UNITED STATES PATENT AND TRADEMARK OFFICE

APPLICATION NO.	FILING DATE	FIRST NAMED INVENTOR	ATTORNEY DOCKET NO.	CONFIRMATION NO.
10/597,995	07/02/2007	Fred Van Essen	031707/315410	8930
826 7590 02/18/2010 ALSTON & BIRD LLP BANK OF AMERICA PLAZA 101 SOUTH TRYON STREET, SUITE 4000 CHARLOTTE, NC 28280-4000			EXAMINER YUSUF, MOHAMMAD I	
			ART UNIT	PAPER NUMBER
			3725	
			MAIL DATE	DELIVERY MODE
			02/18/2010 PAPER

Office Action Summary

DETAILED ACTION

Smith, Figure 1

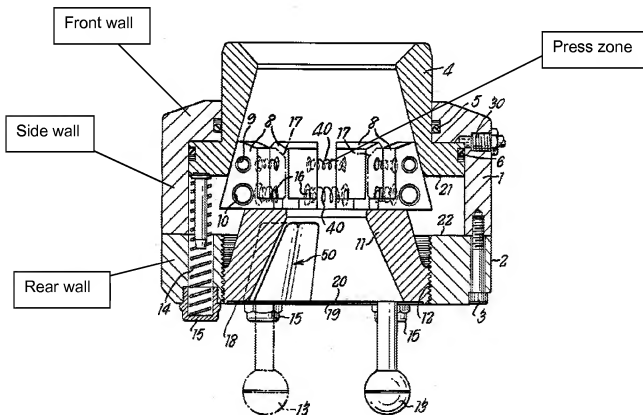
4. Claims 1-3 is rejected under 35 U.S.C. 102(b) as being anticipated by Smith (US 4,107,964).
5. In regard to **claims 1**, Smith discloses a head assembly [fig. 1] for a swage press including a housing [1] having a peripheral side wall [illustrated on next page] that extends continuously and completely about a circumference of the housing, a front wall [illustrated on next page] integrally formed with said peripheral side wall with an opening in said front wall providing access to a press zone [illustrated on next page] surrounded by said peripheral side wall, said housing having an open rear face [illustrated on next page]; a rear wall [2, illustrated on the next page] secured by fastening means [3] to said peripheral side wall to at least partially close said rear face of the housing, and a hydraulically operated press mechanism [abstract] located within said housing surrounding said press zone. In regard to **claim 2-3**, Smith discloses [in addition to the limitations claimed in both claims 1 and 2] a plurality of shoe elements [die holder 8] having press surfaces [dies 17] facing radially toward said press zone with said shoe elements being arranged circumferentially about said press zone and being restrained by said front wall [front wall as illustrated below, restrains ring or piston 4, which in turn restrains the shoe elements 8] to move in a radial direction toward and away from said press zone [figures 1-3]; an operating piston means [ring 4] cooperable simultaneously [fig. 1-3]] with each of said shoe elements [8] whereby movement of said operating piston means toward said front wall causes movement of said shoe elements in said

radial direction inwardly toward said press zone [figs. 1-3]; and a rear wall [2, illustrated below] secured by fastening means [3] to said peripheral side wall [illustrated below] to at least partially close said rear face of the housing, said rear wall [2] cooperating [by 14] with said operating piston means [4] to define at least one chamber [7, figure 3] for receiving high pressure hydraulic fluid to effect movement of said operating piston means toward said front wall.
